Minutes of the 2nd Meeting of the ER P24 Task Group

23rd September 2015

RP presented the latest working draft of P24 (*ENA_EREC_P24_Working Draft_22.09.15*) and the Task Group engaged in the following discussions.

6.1 Metering CB location

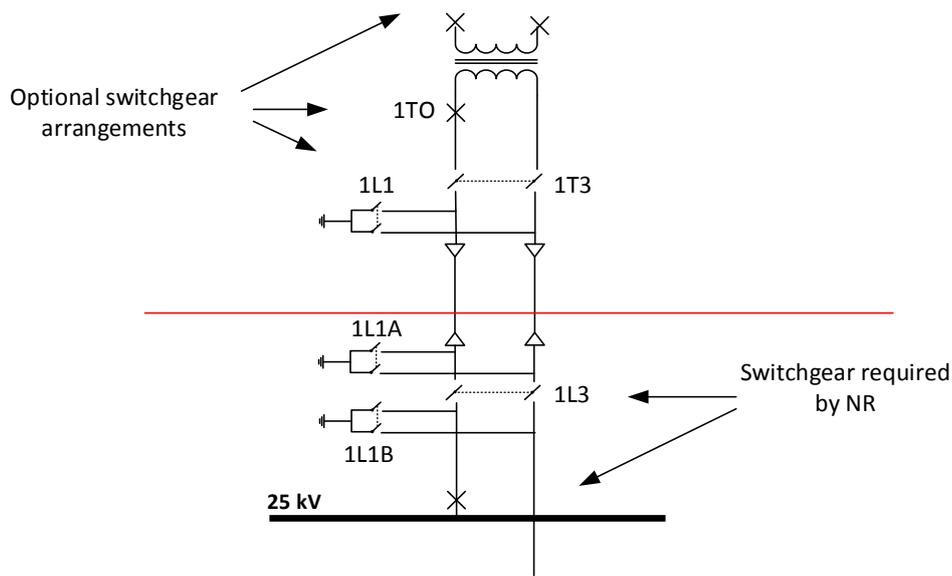
A basic diagram of a typical 25 kV connection was presented to the Task Group. GBr commented that ESQCR and EAWR regulations must be satisfied. PJ commented that duplication of equipment should be avoided. DH commented that Network Rail have a minimum requirement to have a circuit-breaker and disconnector at the traction compound. It was agreed that beyond the minimum requirements for Network Rail, the Network Operator requirements will depend on the design of the connection. A typical connection diagram should be shown in P24 indicating the equipment which is optional. An example is shown below.

ACTION 2: RP to prepare typical connection diagrams showing the optional equipment for consideration by a Network Operator.
